Info Only: Comments from Service
Engineering and Stormwater Engineering
are in blue text.

EPC STORMWATER REVIEW COMMENTS
IN ORANGE BOXES WITH BLACK TEXT

Final Drainage Report
for
Rolling Hills Ranch North Filing 2
at
Meridian Ranch

July 2024

No.	Date	Appr.	Date

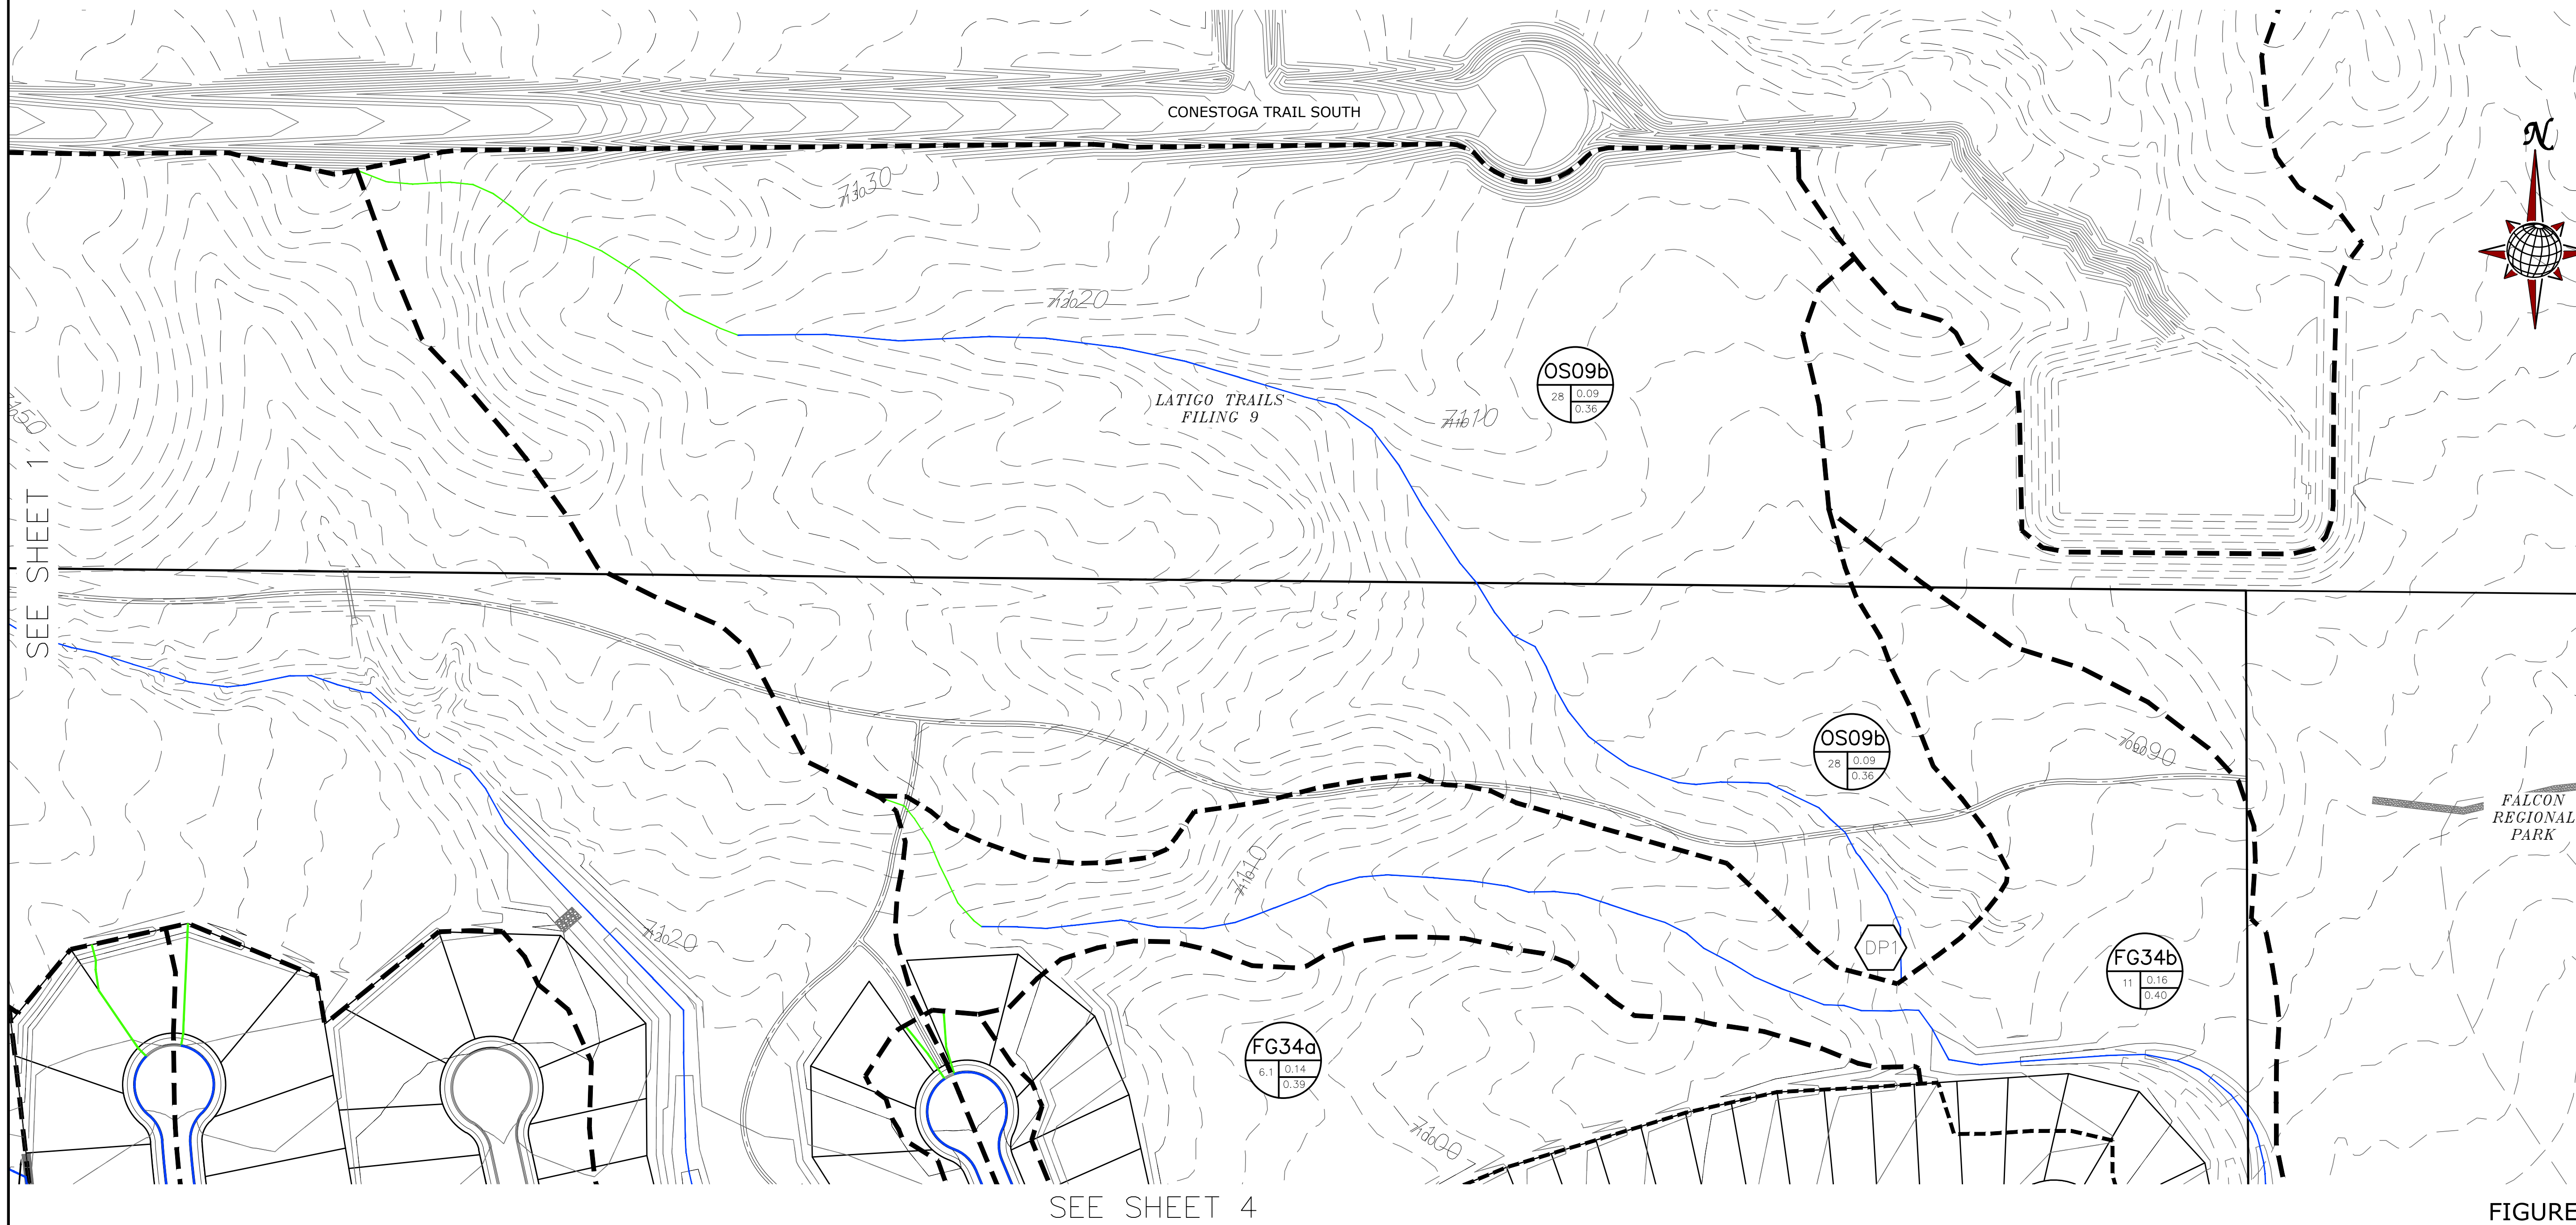
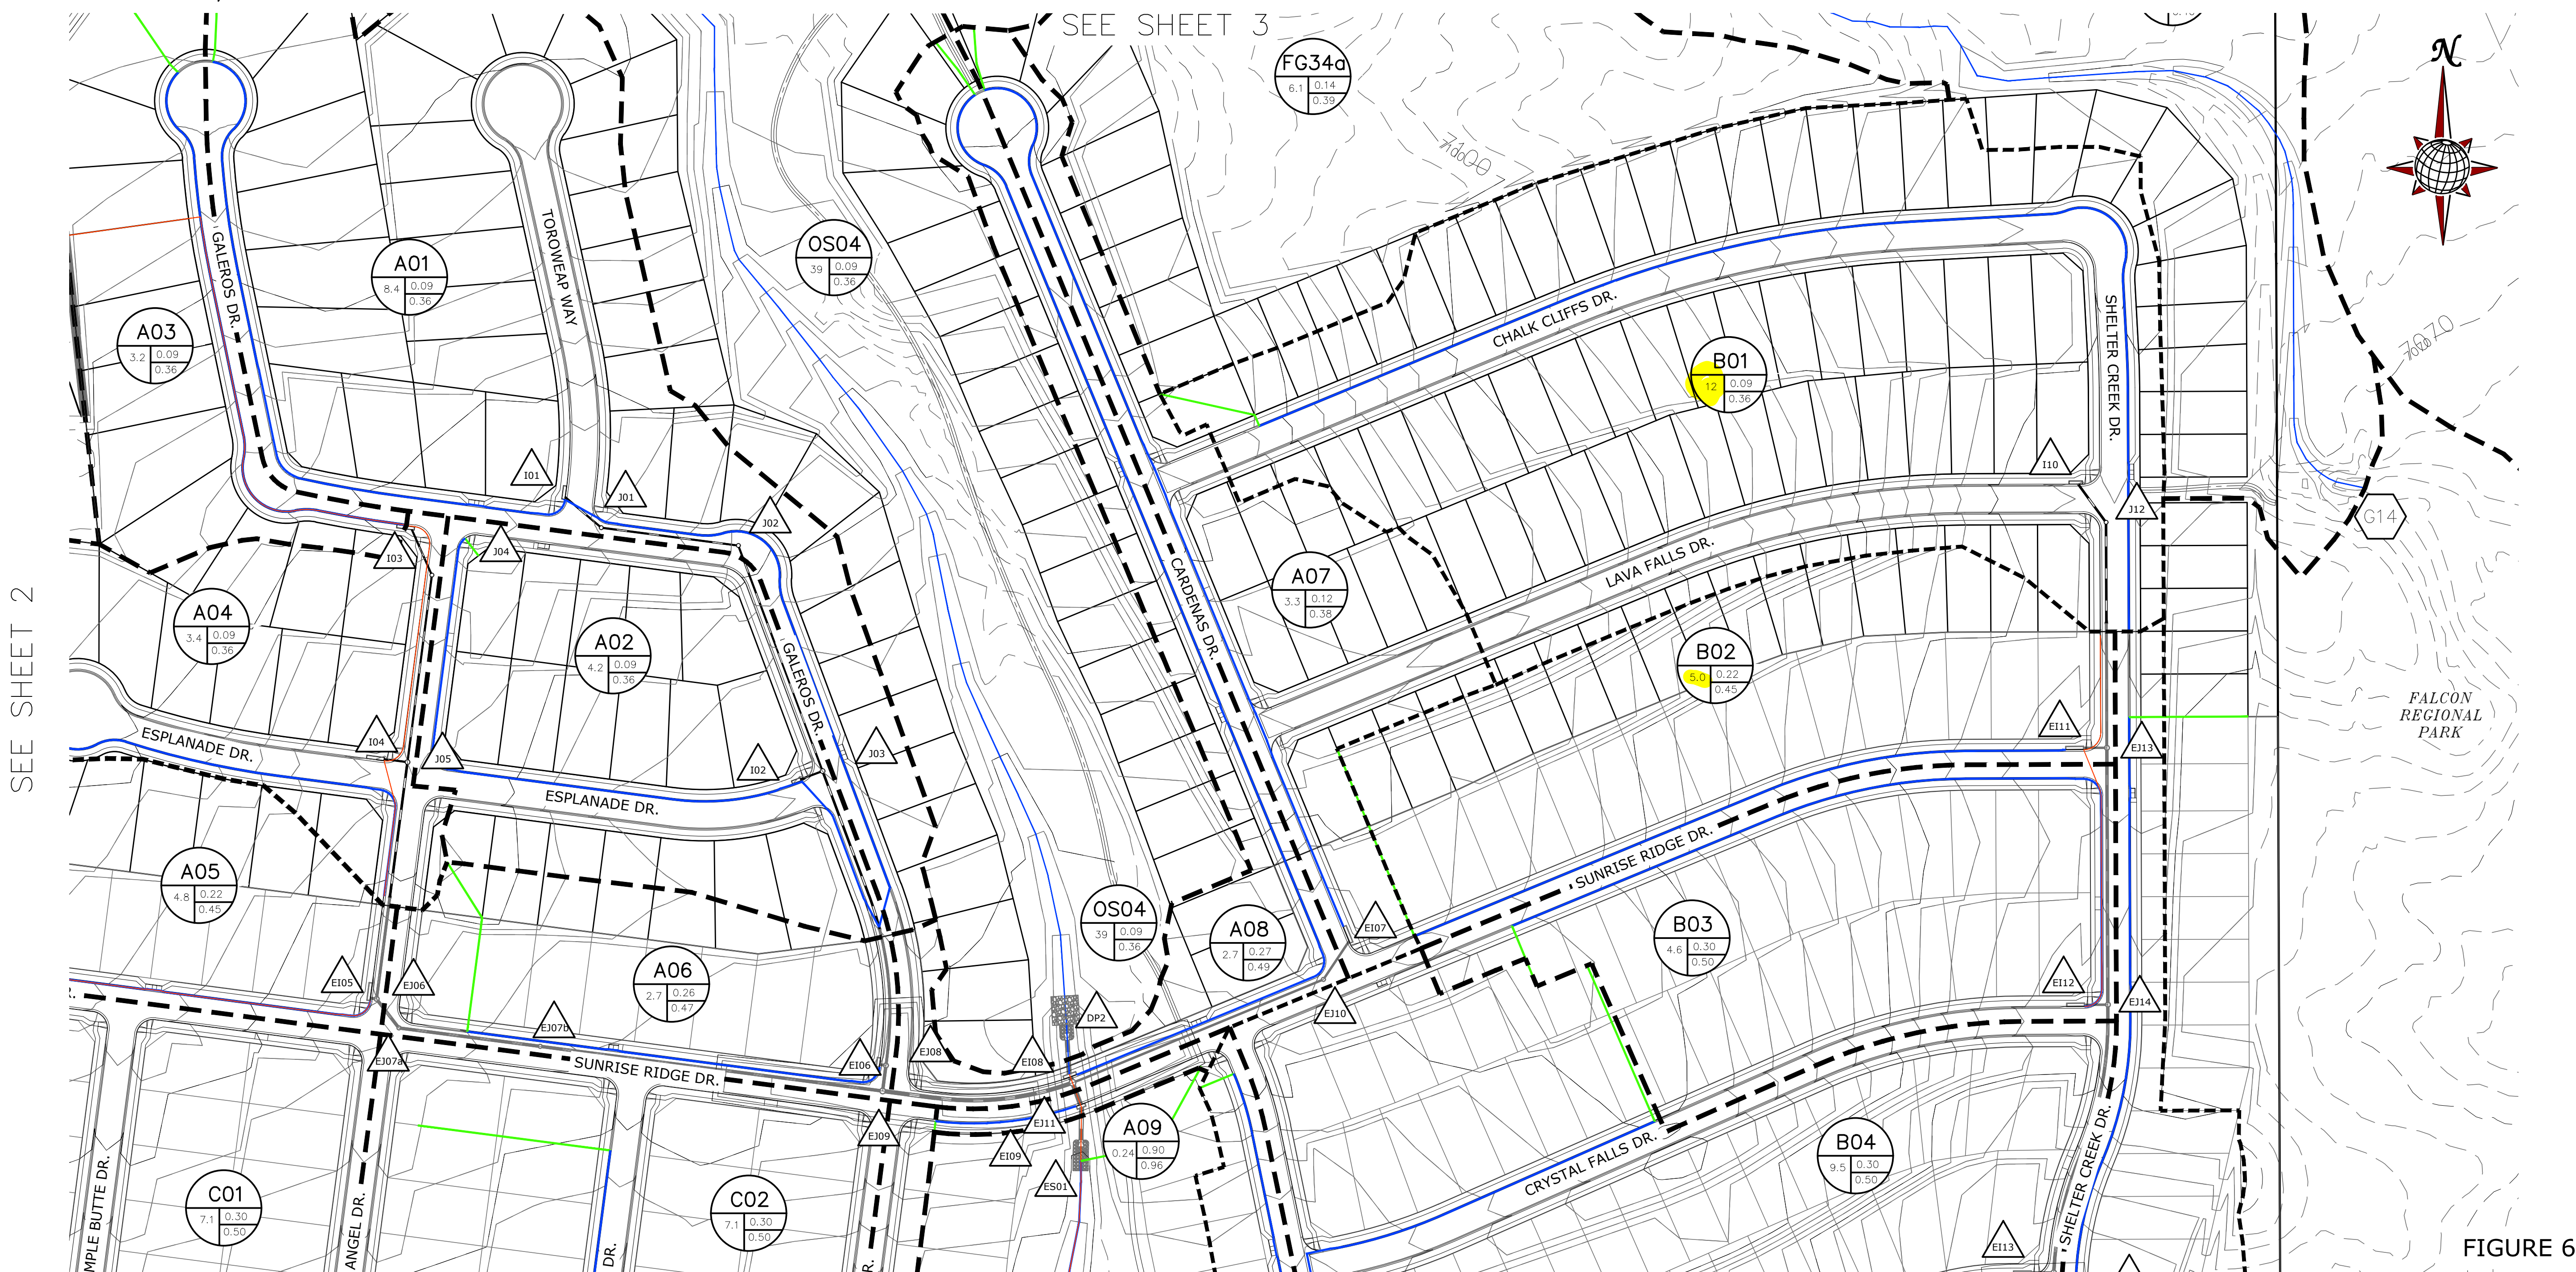
The chart shows data from the storm drain system and does not include surface runoff.
 No change

FIGURE 7

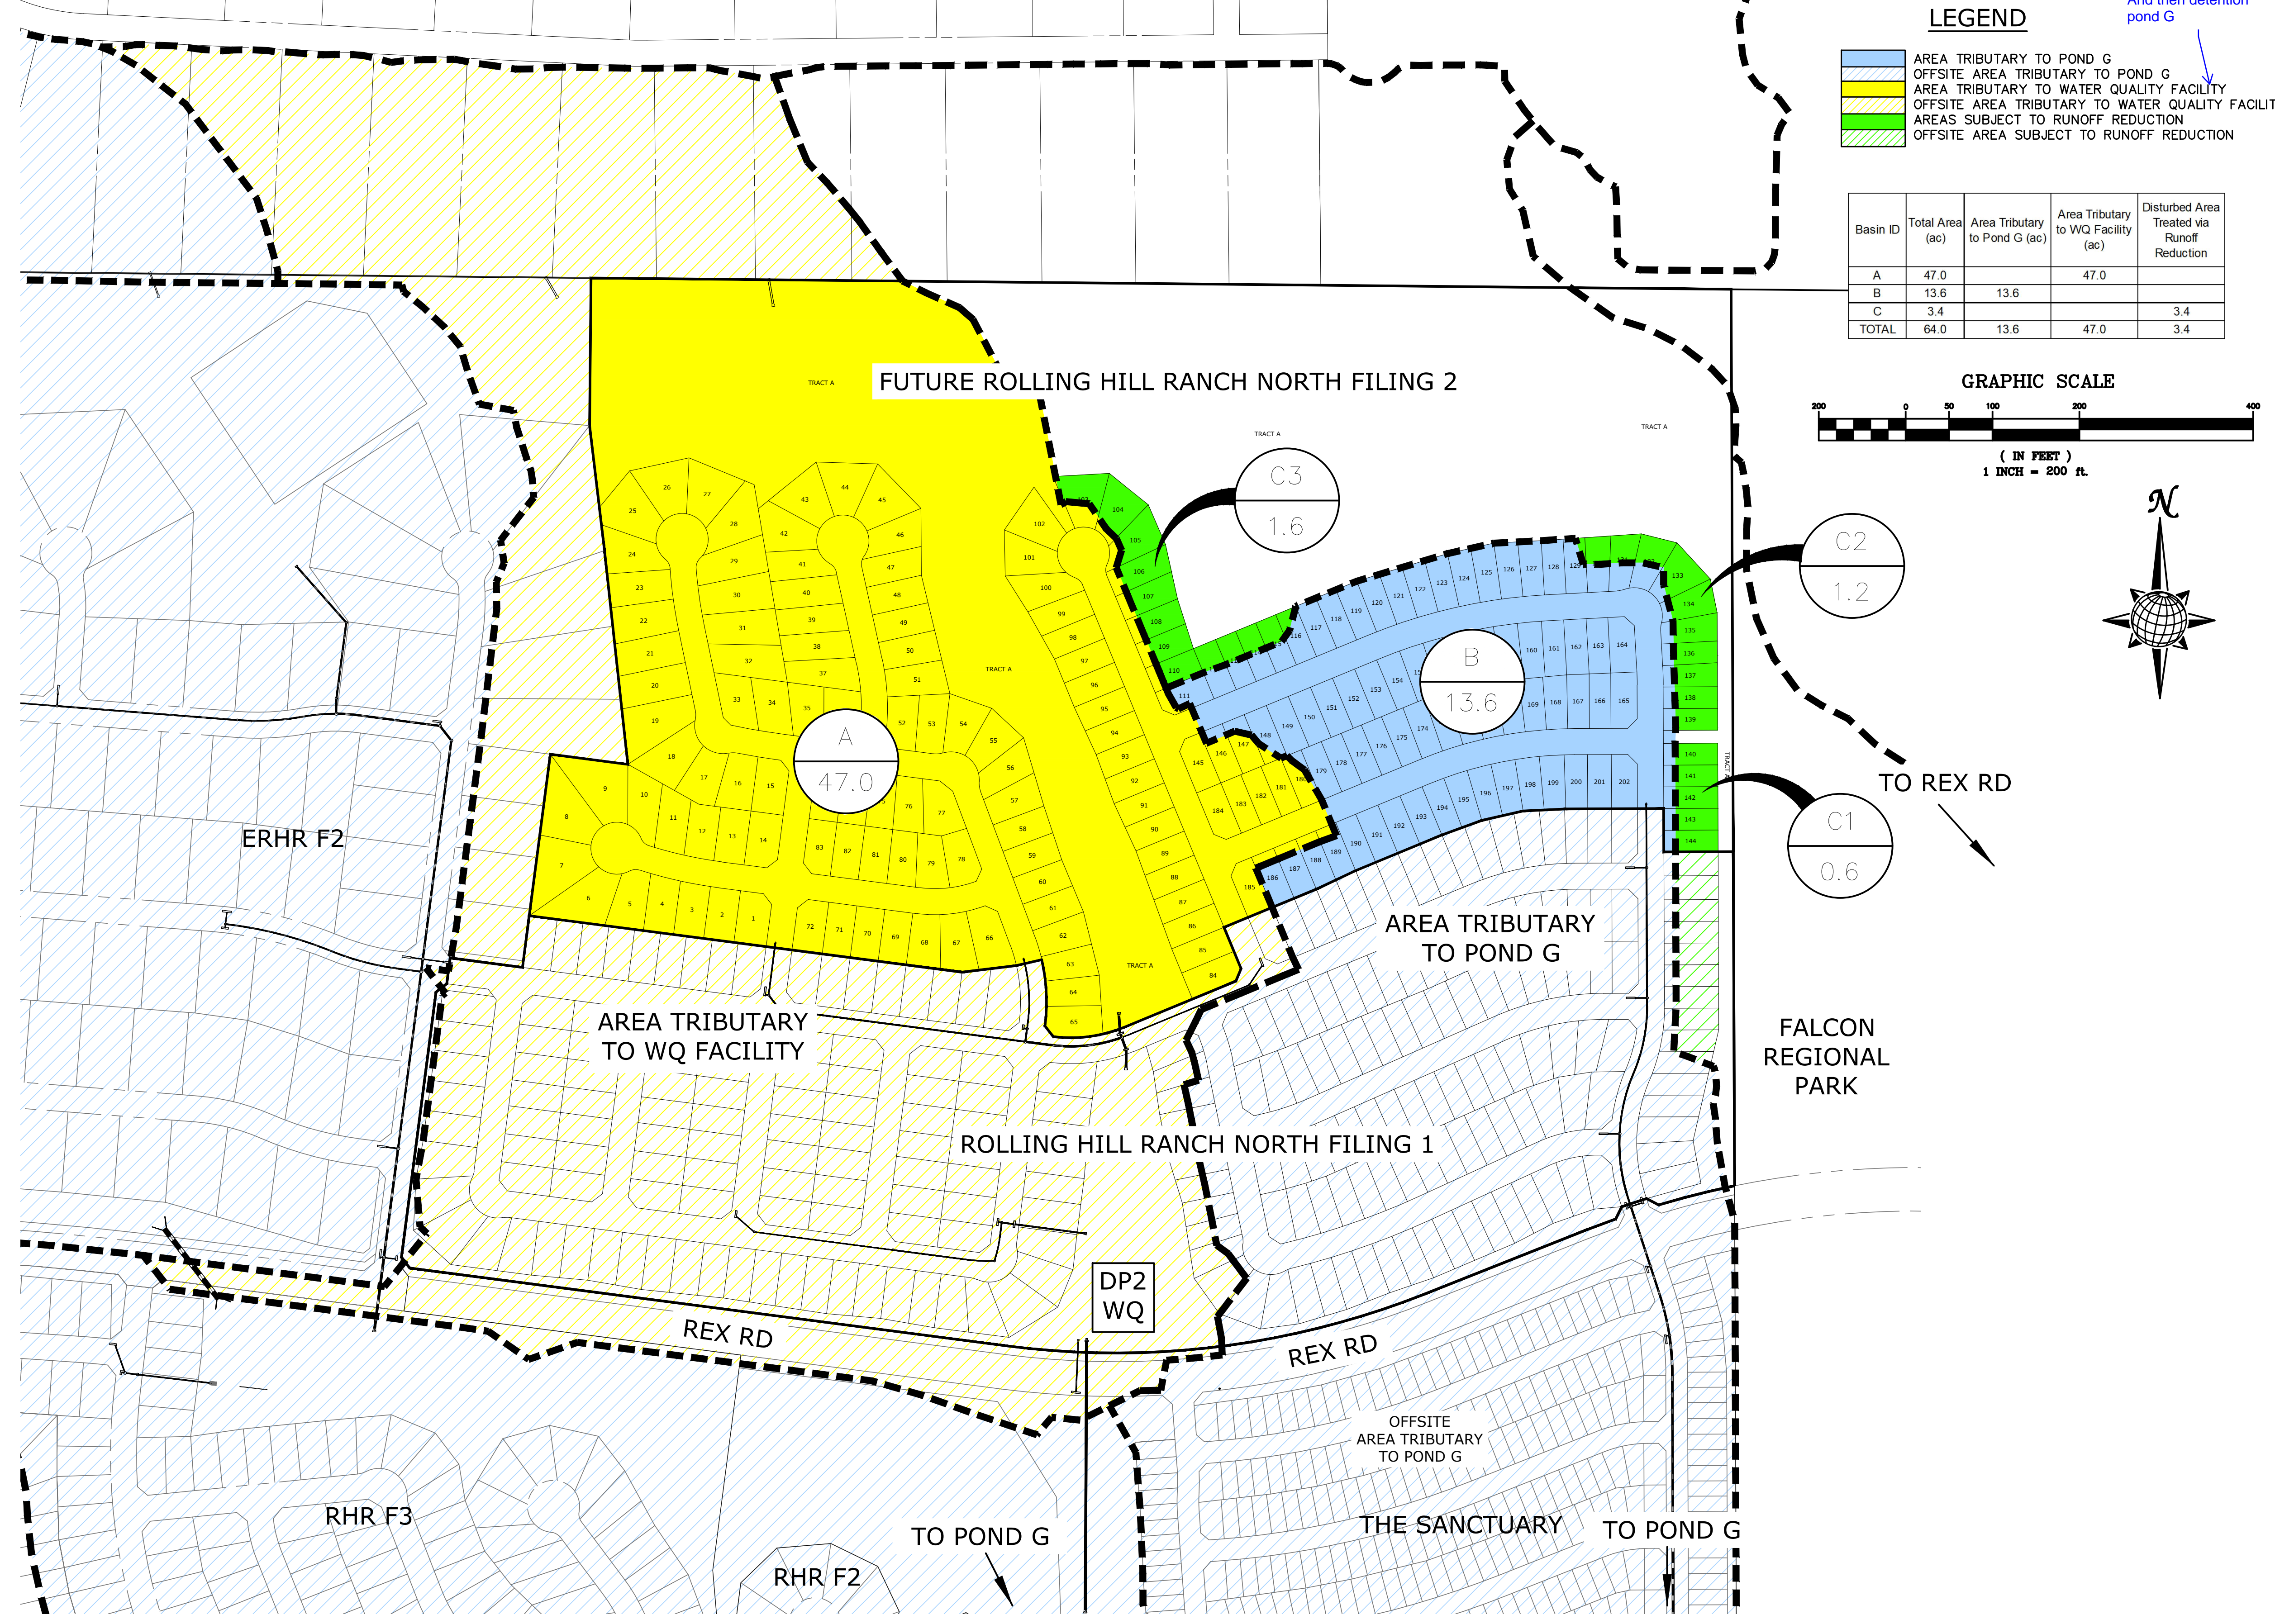
No change per conversation with Daniel (Oct 29, 2024)
And then detention pond G
